12B Spent Fuel Pool Geometry and Dose Rate Calculation

Figure 12B-1 ~~SFP Layout and Dimensions~~ Spent Fuel Pool Analytical Model

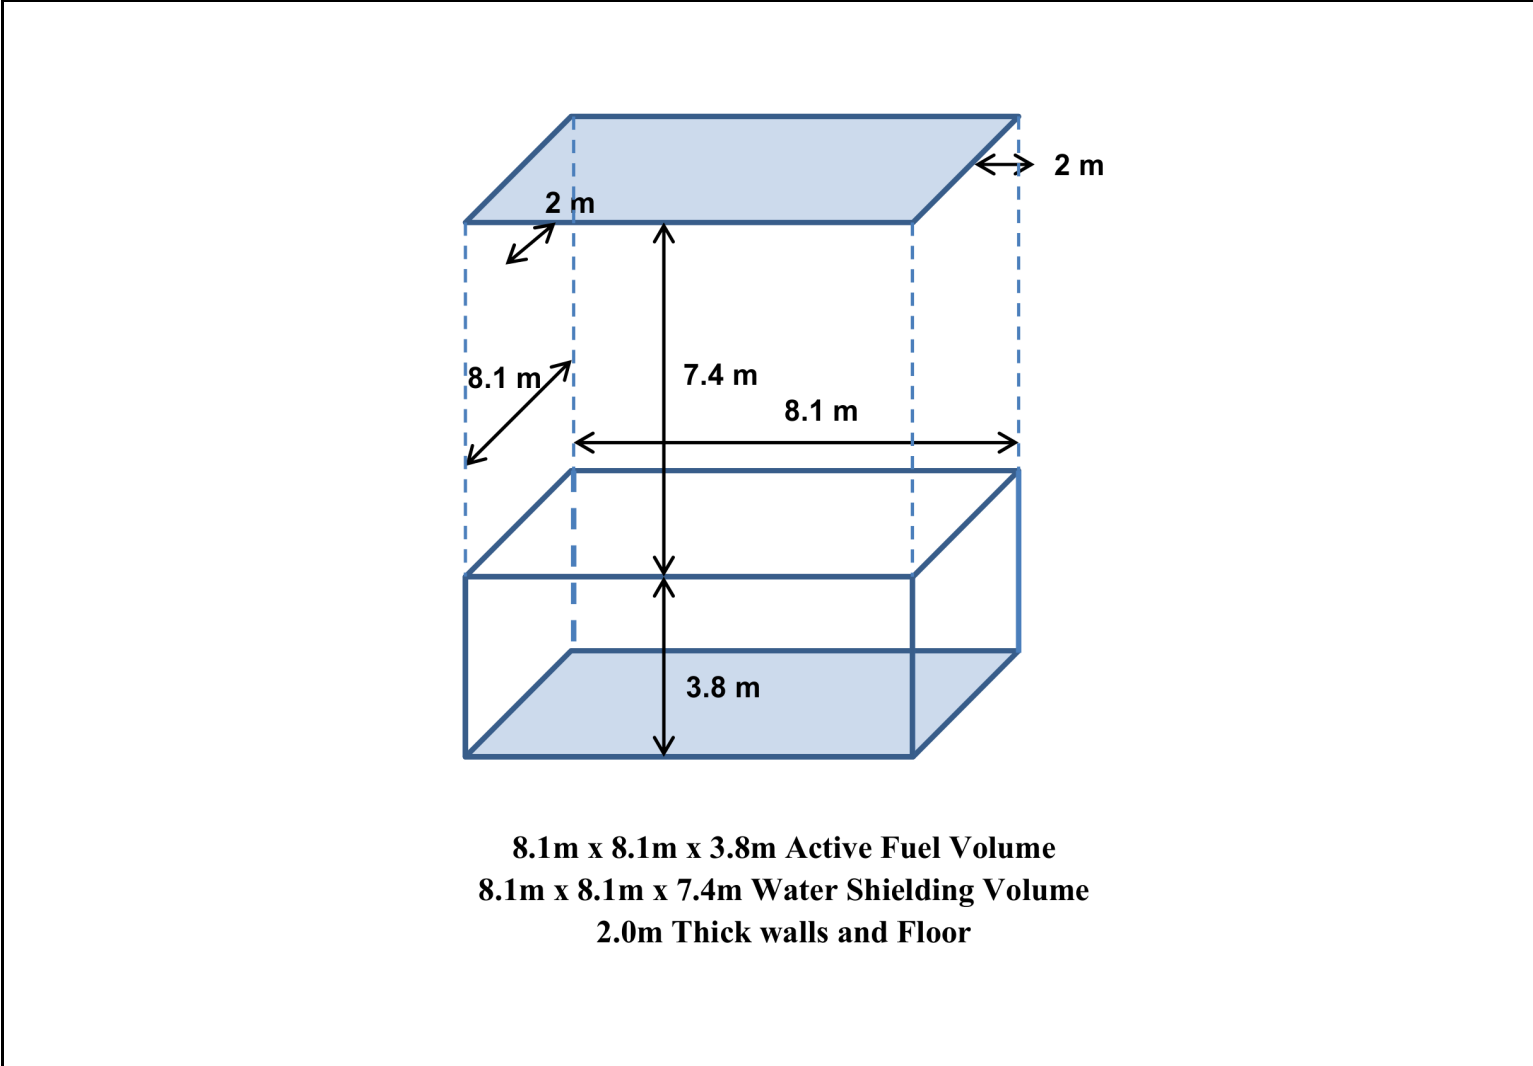
~~The SFP geometry is provided in FSAR Section 12.2, Tables 12.2-5a and 12.2-5b; and FSAR Section 12.3, Figures 12.3-6 and 12.3-10. The SFP storage rack has the capacity for 2365 BWR fuel assemblies. The size and configuration of the storage rack are given in Figure 12B-1, which shows an irregular rectangular cross section area extended to 10.7 m x 9.0 m. The fuel storage rack is situated at the lowest level of the SFP, where the total height of water is 11.6 m.~~

The SFP radiation source is used for the shielding design and analysis to ensure radiation levels at neighboring areas surrounding the SFP meet the design criteria. A simplified model of a rectangular parallelepiped of (8.1 m x 8.1 m x 11.2 m) is assumed to represent the SFP. The SFP peak radiation source is assumed to be homogenized over the bottom 3.8 m of the SFP to represent the active fuel length of a typical BWR fuel assembly. 3.8 meters was assumed to represent the height of the active fuel region, since this height results in the minimum required shielding of water. 11.2 m – 3.8 m = 7.4 m (see Table 12.2-5c). ~~There are 2-m thick concrete walls and floor surrounding the SFP on all sides. The floor of the SFP is 2 meters thick as well (see Table 12.2-5c). The water shielding and distance between the spent fuel racks and the surrounding walls in the pool are not considered. (See Figure 12B-1).~~ The dose rate calculations are carried out with the point-kernel shielding code QAD-CGGP-A (Reference 12B.6-2). The calculated dose rate results indicate all the areas surrounding the SFP meet the reactor building (R/B) radiation zone limits. Figure 12B-2 shows the dose rate profile for a set of detectors along the centerline of the SFP perpendicular to the water surface. The D~~ose~~ rate at the water surface is approximately 0.001 $\mu\text{rem/hr}$ ($1\text{E-}5$ $\mu\text{Sv/hr}$). The dose rates assessed are due to fuel assemblies in the SFP alone. Contributions from contaminants in the SFP water are not included.

Figure 12B-3 Maximum Single Bundle Dose Rate at Refueling Platform

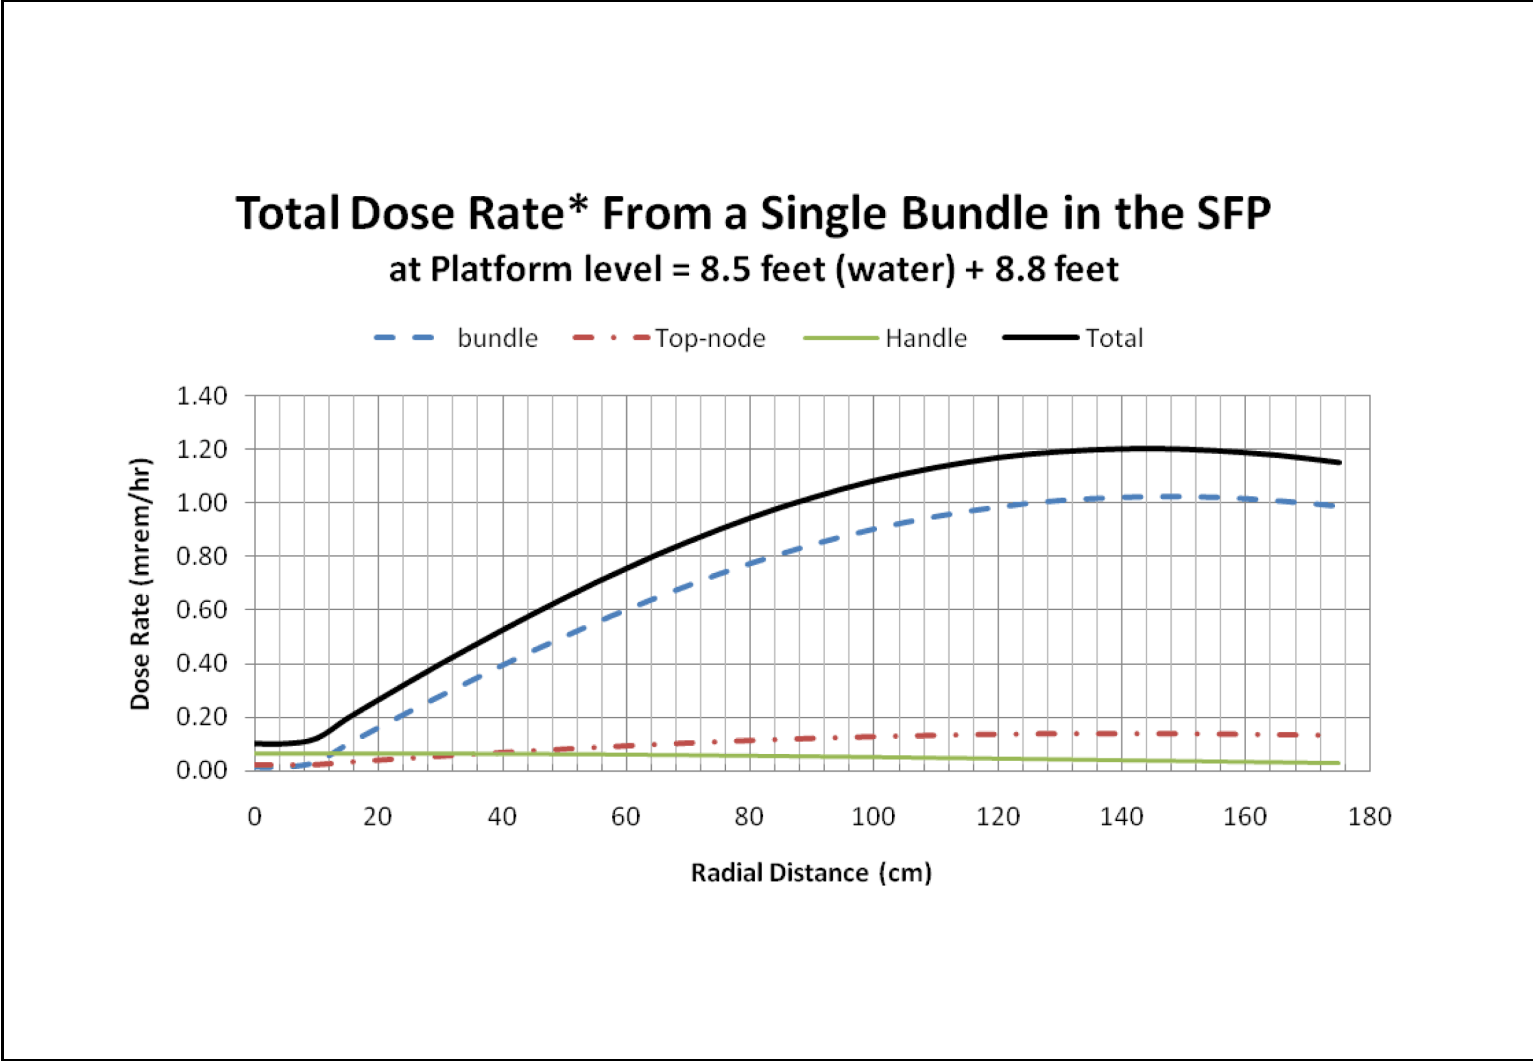
It is assumed that the fuel assembly is lifted to a height of 8.5 ft (2.6 m) below the pool water surface with the operator on the refueling machine trolley platform at a minimum of 8.8 ft (2.7 m) above the water surface. The resulting peak dose rate at 8.8 ft (2.7 m) above the water surface is approximately 1.2 mrem/hr, located at a radial distance from the fuel assembly of approximately 140 cm (4.6 ft) as shown in Figure 12B-3. Even when the maximum fuel pool water source (see Section 12B.5 below) is added, the dose rate remains below 2.5 mrem/hr. For an operator standing on the trolley platform, the dose rate will be less than that shown in Figure 12B-3; therefore the design criteria of ANSI/ANS-57.1-1992 has been satisfied.
